APPLICATION NO.	FILING DATE	FIRST NAMED INVENTOR	ATTORNEY DOCKET NO.	CONFIRMATION NO.	
09/912,103	07/23/2001	Huong Thanh Nguyen	5619/DD/LOW K/JW	4476 NER	
32588	7590 02/22/2006		EXAM		
	IATERIALS, INC.		NGUYEN, KHIEM D		
	BLVD. M/S 2061 RA, CA 95050		ART UNIT	PAPER NUMBER	
	,		2823		
			DATE MAILED: 02/22/2000	6

DETAILED ACTION

Claims 1-7, 9-15, and 17-24 are rejected under 35 U.S.C. 102(e) as being anticipated by Annapragada et al. (U.S. Patent 6,518,174).

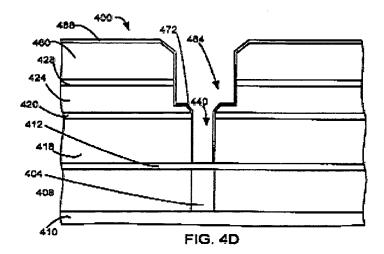
In re claim 2, <u>Annapragada</u> discloses that the method of claim 1, further comprising:

(f) etching the silicon oxide layer 420 to transfer the vias 440 defined in the second organosilicate layer 424 therethrough (FIG. 4C);

(g) patterning the second organosilicate layer 424 to define interconnects 464 therethrough, wherein the interconnects 464 are positioned over the vias 440, and wherein the via pattern is transferred through the first organosilicate layer 416 when the interconnects 464 are defined in the second organosilicate layer 424 (FIG. 4D); and

(g) filling the vias **440** and interconnects **464** with a conductive material. The dual damascene structure as disclosed by Annapragada in FIGS. 4D-E eventually will be filled with a conductive material selected from the group consisting of copper, aluminum or tungsten to obtain an interconnect structure.

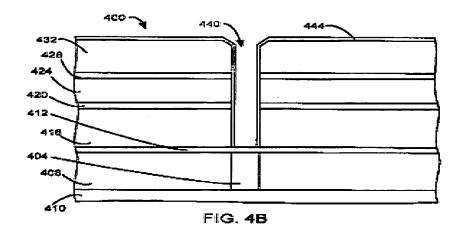
In re claim 21, <u>Annapragada</u> discloses a method of fabricating a damascene structure, comprising: (a) forming a barrier layer 412 on a substrate 410 having a metal layer 404 thereon; (b) forming a first organosilicate layer 416 on the barrier layer 412;

(c) forming a silicon oxide layer 420 on the first organosilicate layer 416; (d) forming a second organosilicate layer 424 on the silicon oxide layer 420 (col. 2, line 46 to col. 3, line 21 and FIGS. 4A-B); and

- (e) etching the second organosilicate layer **424** to define vias **440** therein, wherein the second organosilicate layer **424** is etched with a gas mixture comprising one or more hydrogen-containing fluorocarbon gases and one or more gases selected from the group consisting of hydrogen (H₂), nitrogen (N₂), oxygen (O₂), argon (Ar), and helium (He) (col. 4, lines 9-23); and
- (f) etching the silicon oxide layer 420 to transfer the vias 440 defined in the second organosilicate layer 424 therethrough, wherein the silicon oxide 420 is etched with a gas mixture comprising a fluorocarbon gas (col. 9, lines 9-23);
